Access Compliance Report

Public Rights-of-Way

(Curb Ramps)

Intersection ID: 2513	Main Street: BENTGRASS_RUN_DR	Cross Street: COPPERMINE_LN	Location: SW
ADA ID: 3C82395A2ECF	Ramp Type: PerpDiag	Initial Pass/Fail: Pass	Overall Compliance: No
Severity Score: 22.5			
Codes/Mitigation Info/Possible Solution		Field Measurements/Component Compliance

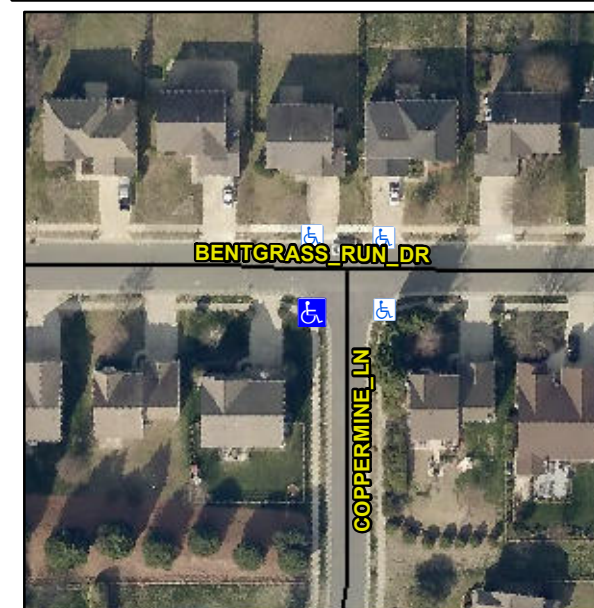
R304.2.2-Perp, R304.3.2-Para, R304.5.3, R305, R302.7.2, R304.5.4

Compliance	Description	Data	Compliance	Description	Data
N/A	Ramp Length (in)	47.0	Yes	Ramp Slope (%)	6.2
Yes	Ramp Width (in)	48.0	Yes	Ramp XSlope (%)	2.0
N/A	Flare Type LT	Sloped	N/A	Flare Type RT	N/A
N/A	Flare Slope LT (%)	6.0	N/A	Flare Slope RT (%)	8.7
N/A	Flare Traversable LT?	No	N/A	Flare Traversable RT?	No
Yes	Landing Length (in)	48.0	No	DWS Provided?	No
Yes	Landing Width (in)	48.0	N/A	DWS Contrast?	No
No	Landing Slope (%)	3.1	N/A	DWS Length (in)	N/A
No	Landing X Slope (%)	2.9	N/A	DWS Full Width?	No
N/A	Landing Curb? (Y/N)	No	N/A	DWS Offset (in)	N/A
N/A	Shared Landing?	No			
Yes	Gutter Ponding?	No	No	Gutter Slope (%)	7.1
No	Gutter Lip Ht (in)	0.5	Yes	Gutter X Slope (%)	1.3
N/A	Painted X Walk1?	No	N/A	Painted X Walk2?	No
	X Walk 1 Direction	To E		X Walk 2 Direction	To N
N/A	X Walk 1 Width (in)	N/A	N/A	X Walk 2 Width (in)	N/A
	X Walk 1 Slope (%)	1.0		X Walk 2 Slope (%)	4.1
	X Walk 1 X Slope (%)	3.4		X Walk 2 X Slope (%)	0.9

N/A	Ramp inside XWalk1?	N/A	N/A	Ramp inside XWalk2?	N/A
	Road Slope (%)	3.0	N/A	Clear Space?	Yes
	Road X Slope (%)	4.2	N/A	Clear Space to XWalk (in)	N/A
Yes	Any Obstructions?	No	Yes	Storm Grate/Utility Hazard?	No
	Obstruction Type			Storm Grate/Utility Type	
		N/A			N/A
			Yes	Surface Condition? (G/P)	Good

Remove & Replace Curb Ramp With Two New Directional Ramps or Equivalent. Remove & Replace Gutter.
